Service Bulletin

SAFETY RECALL

2010-2016 VT750 SERIES - BANK ANGLE SENSOR REPLACEMENT

(This bulletin supersedes VT750C/C2B #5, dated June 2011)

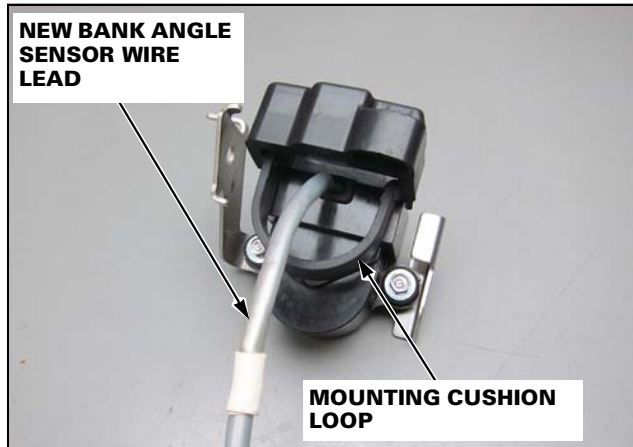
9. Install the new bank angle sensor (has white tape on wire lead) to the stay and bracket in the direction shown.
Install the collars and bolts, then tighten the bolts securely.

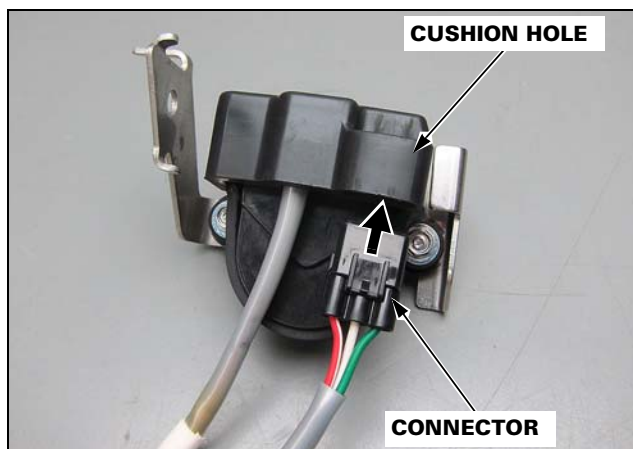
11. Install the mounting cushion onto the update bank angle sensor as shown.

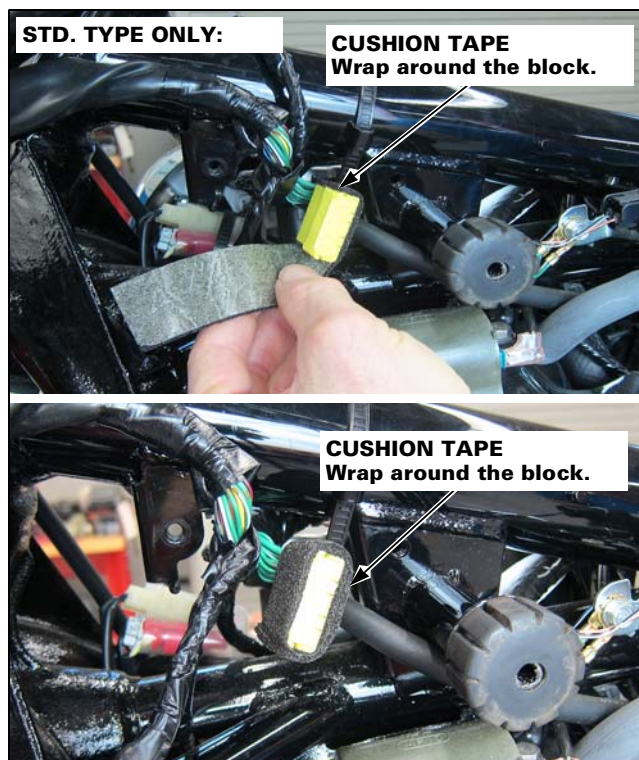
15. **STD. (NON-ABS) TYPES ONLY**

Remove the adhesive backing from the cushion tape.

Wind the supplied cushion tape around the body of the yellow junction block, starting at the narrow edge, as shown.

- Be sure to align the width of the tape with the junction block as shown.

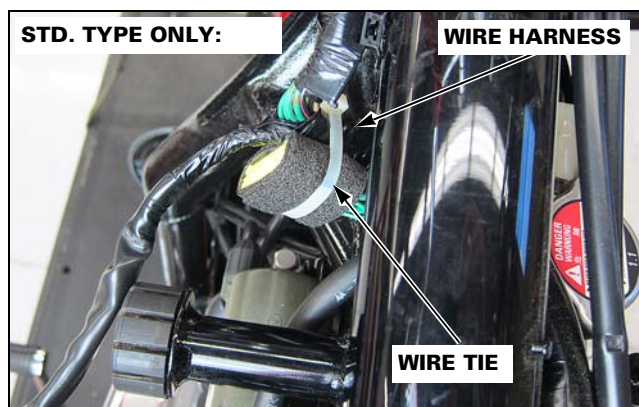
16. **STD. (NON-ABS) TYPES ONLY**

Secure the yellow junction block to the adjacent wire harness with the supplied wire tie as shown.

Wrap the wire tie around the junction block body at the narrow section of the block as shown.

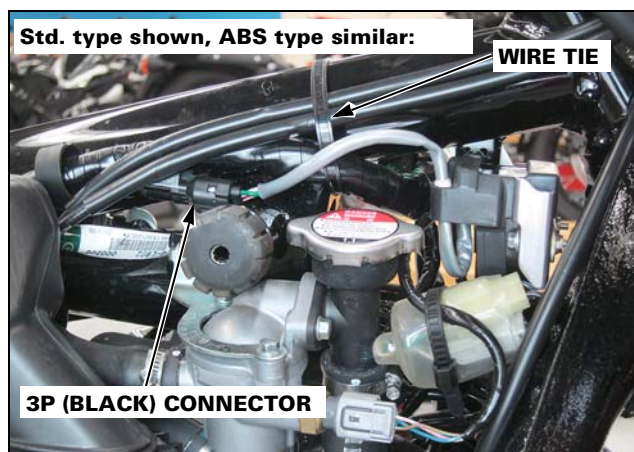
18. Connect the bank angle sensor 3P (Black) connector.

Reinstall the wire tie in the position shown.

- Make sure the bank angle sensor wire is outside the wire tie, as shown.

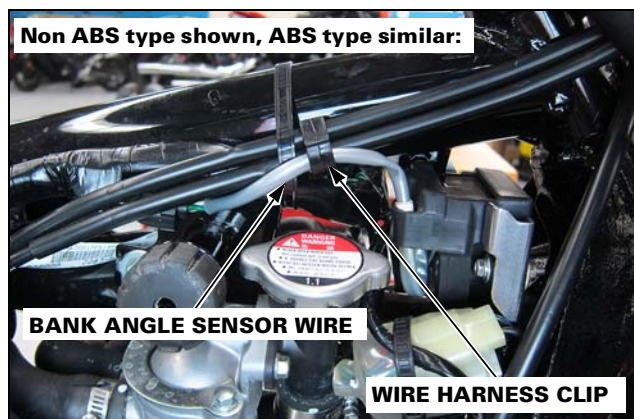
19. Secure the bank angle sensor wire lead to the throttle cables with the supplied wire harness clip as shown.
